AGENDA VIRTUAL BIRMINGHAM DESIGN REVIEW BOARD MEETING

SUBJECT: 470 N. Old Woodward – Design Review (All Updates in Blue Text)

In response to your review dated June 3, 2020 and the comments of the board attendees at the June 3, 2020 meeting, we are submitting attached revised drawings A001, A101, A201, and A202 as well as a revised material/finish sample board to specifically address the concerns regarding the suspended planter, as well as some additional changes to coordinate with the new pergola that replaces the planter element. Please note the following modifications on the attached drawings to the previously submitted proposal:

A001

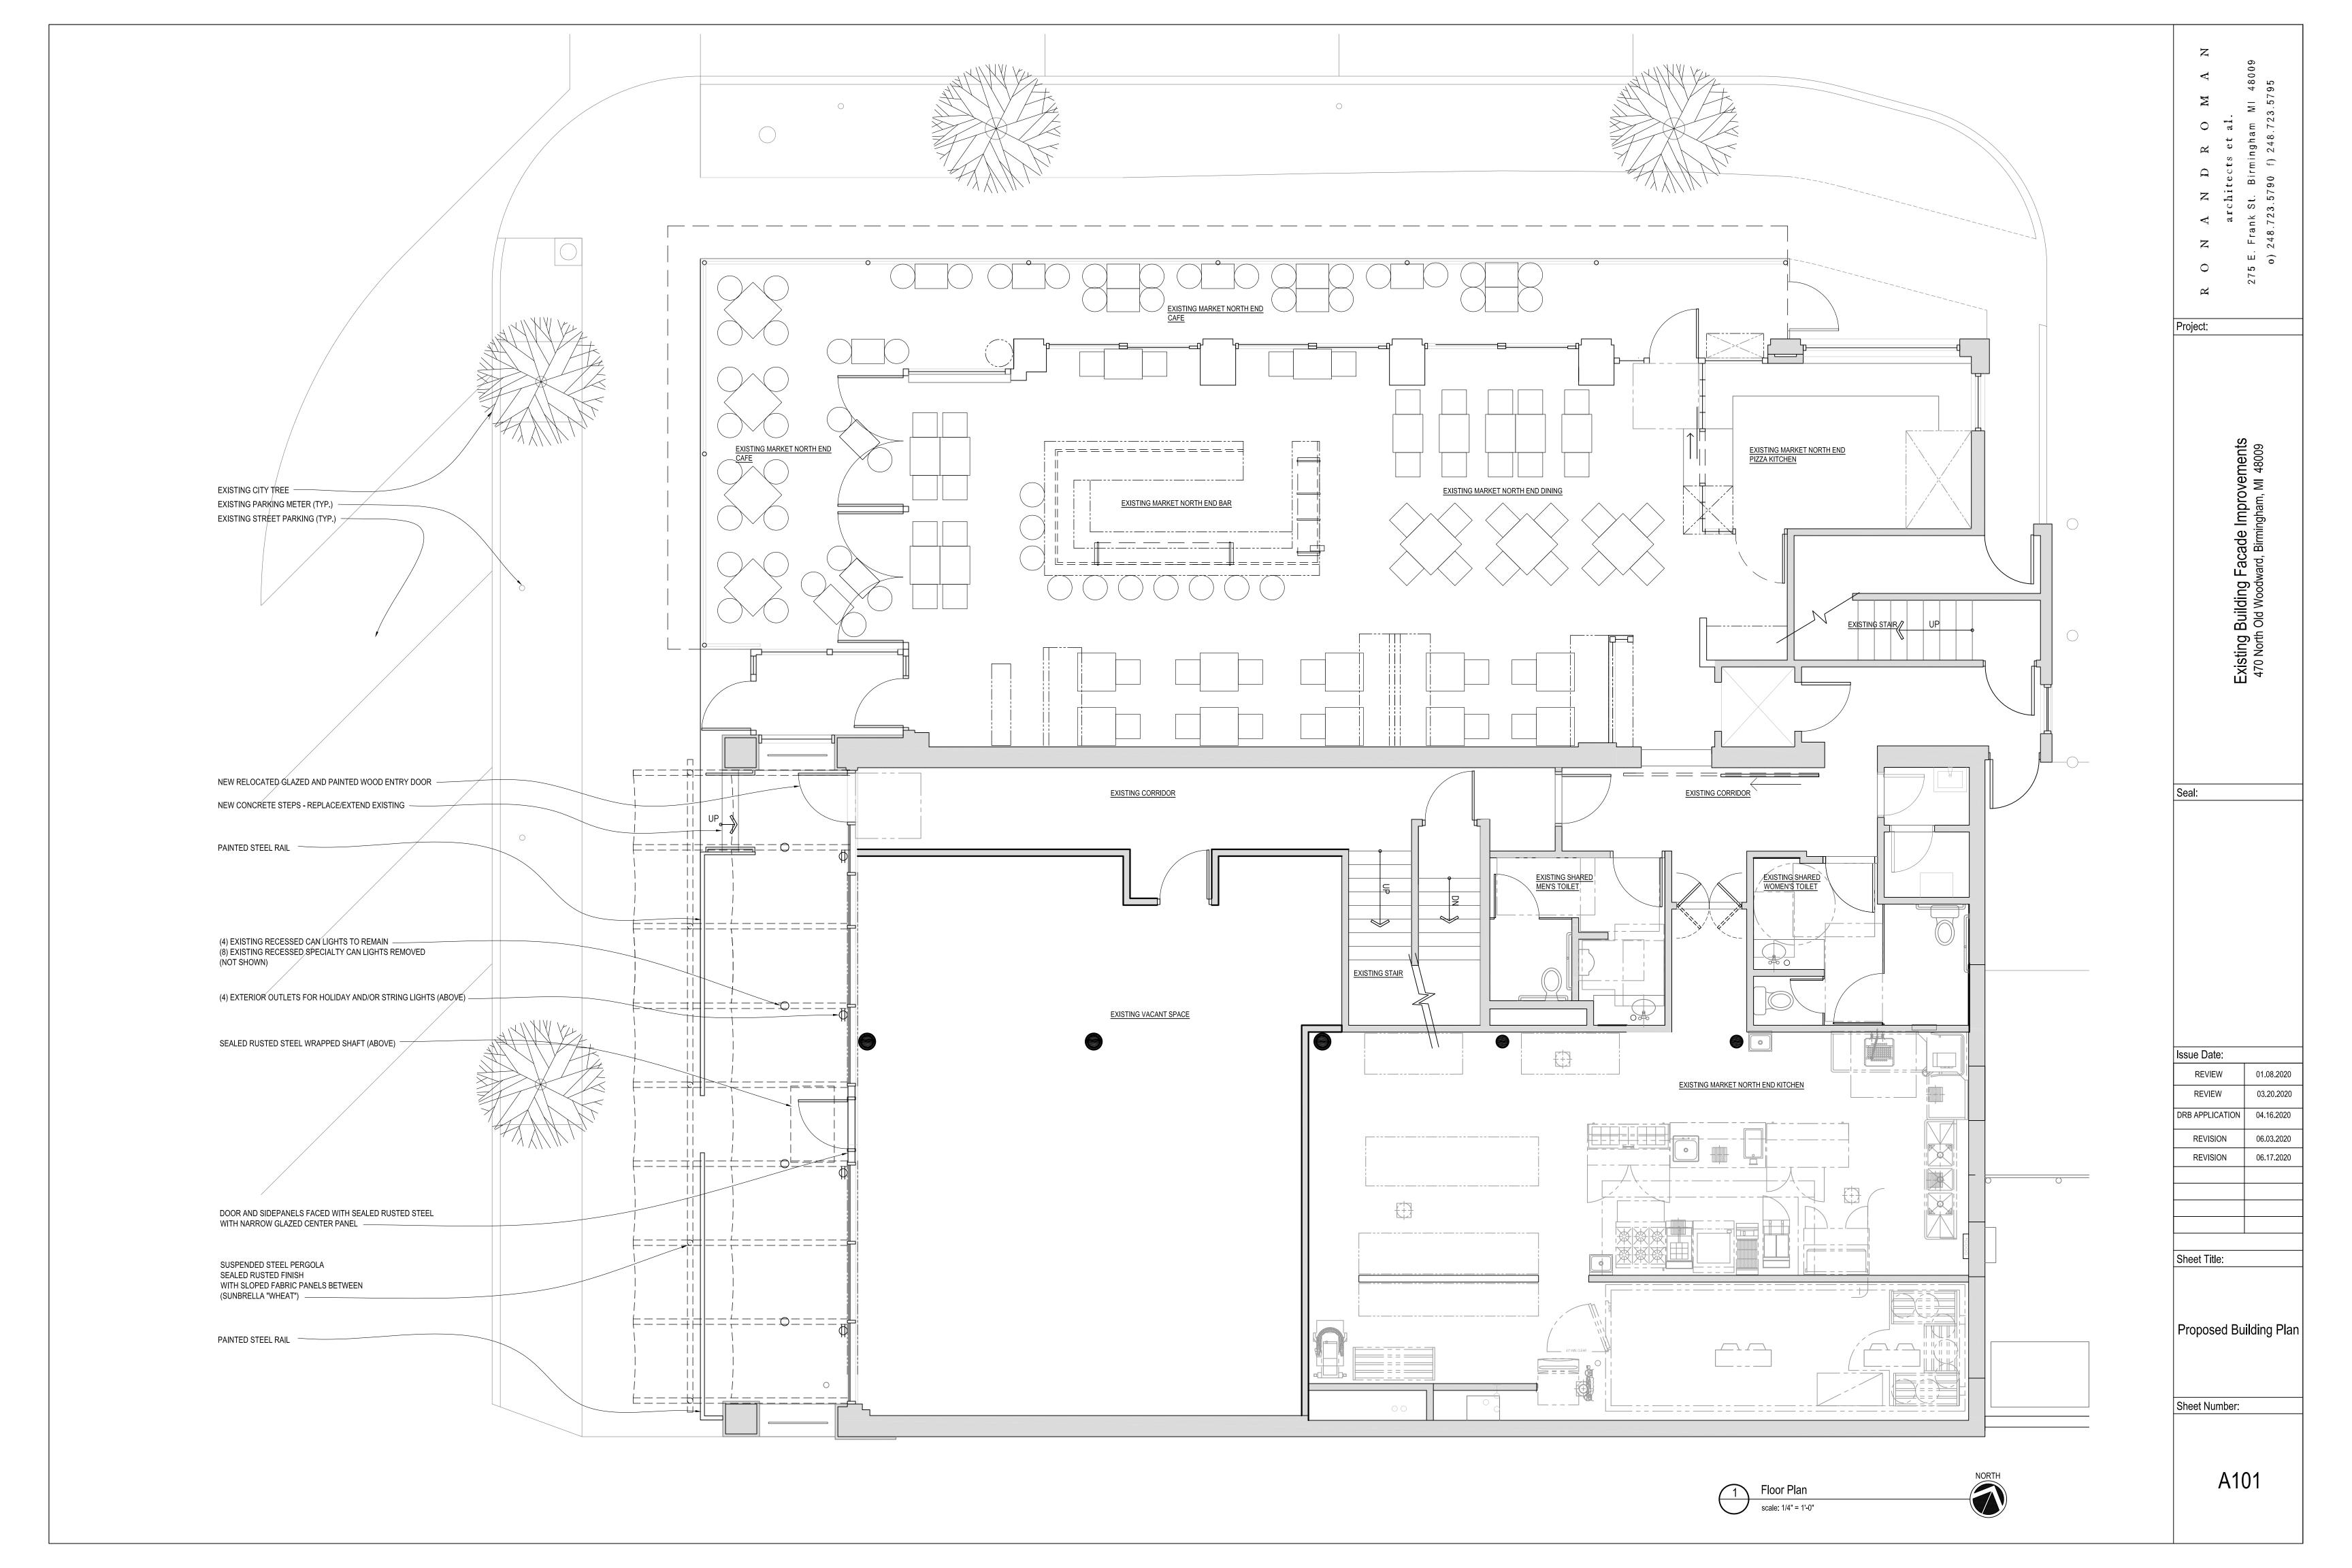
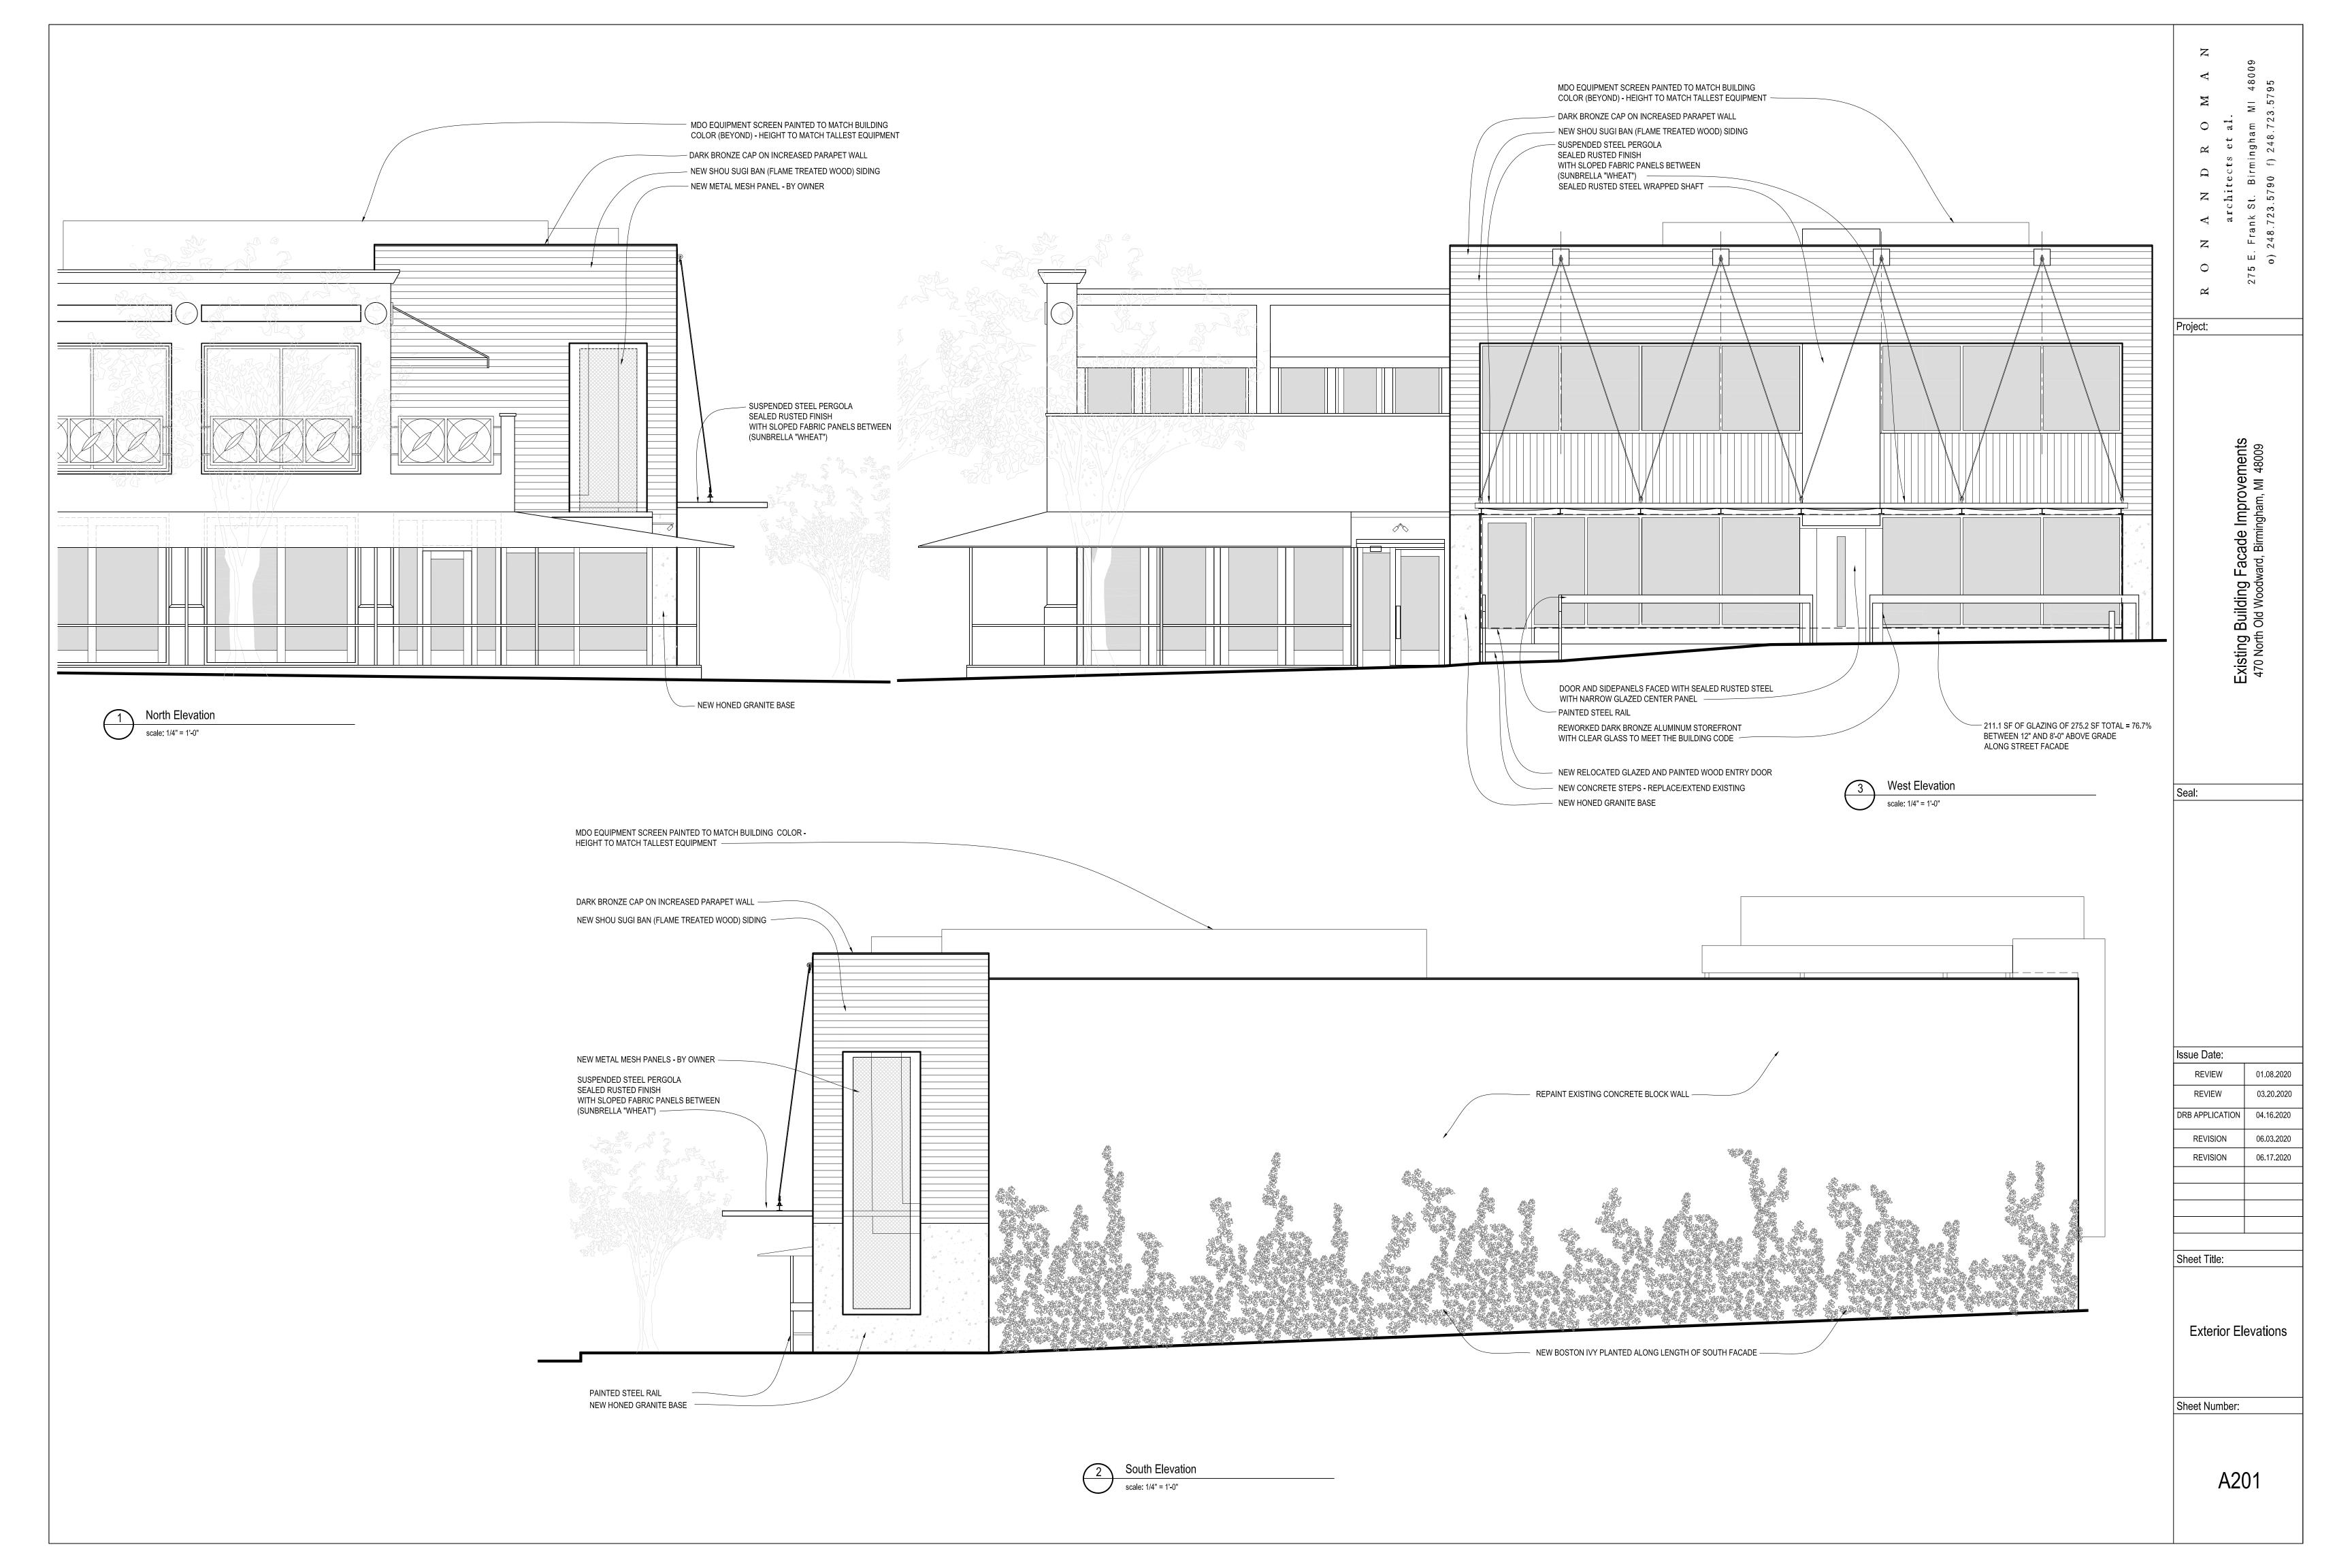
There are two aspects of the proposal that relate to general planning and zoning issues on site. The first issue is the extension of the existing solid waste enclosure in the rear of the building. The proposed site plan (Sheet A001) notes that the extended screening will be comprised of a wood slat gate and screen to match the existing mechanical enclosure. Article 4, Section 4.54 (B)(8) requires trash enclosures to be comprised of a masonry screenwall with wood gates. The screenwall shall match the material of the principal building. The proposal appears to propose a portion of wood slat screenwall that does not meet the Zoning Ordinance, as a masonry screenwall is required. The applicant must revise the site plans to propose a screening extension of masonry with wood gates to match the material of the principal building.

The applicant has submitted revised site plans that show a screenwall extension of concrete block and a wood gate.

CANOPY DETAIL

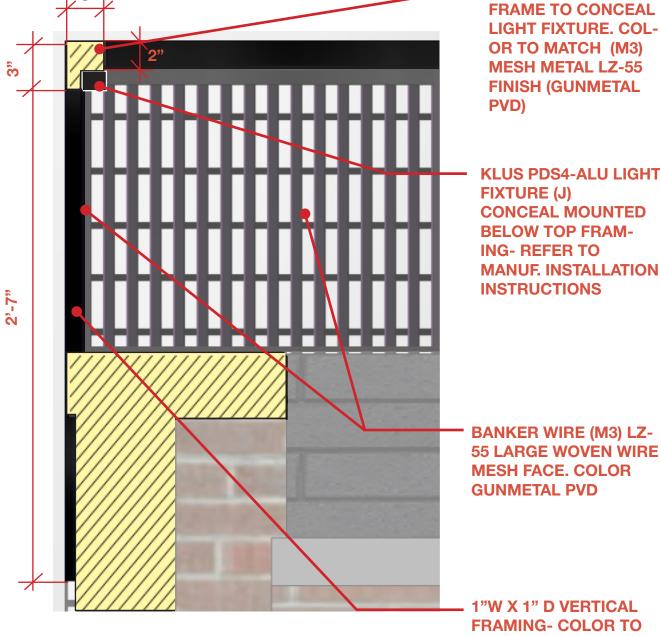
The plans submitted show the proposed canopy at roughly 8 ft. 3 in. from grade. Article 4, Section 4.74 of the Zoning Ordinance outlines the standards for encroachments into the right-of-way (ROW). Removable architectural elements above 8 ft. such as awnings, canopies, and marquees may be approved by the Design Review Board to project into the right of way provided that they are constructed to support applicable loads without any ground mounted supports on public property. Encroachments with less than 15' of clearance above the sidewalk shall not extend into or occupy more than two-thirds of the width of the sidewalk or 5 feet, whichever is less, and must not interfere with any existing or planned streetscape elements or infrastructure.

The sidewalk in front of the building is noted at 6 ft. The above requirements would indicate that two-thirds of the width of the sidewalk is 4 ft. This would require the applicant to redesign the canopy to extend no more than 4 ft. into the ROW, as that is the smaller figure. Thus, **the applicant must submit revised drawings showing a canopy that projects no more than 4 ft. into the ROW**. Additionally, the Design Review Board should discuss the projection and determine whether or not to approve such.
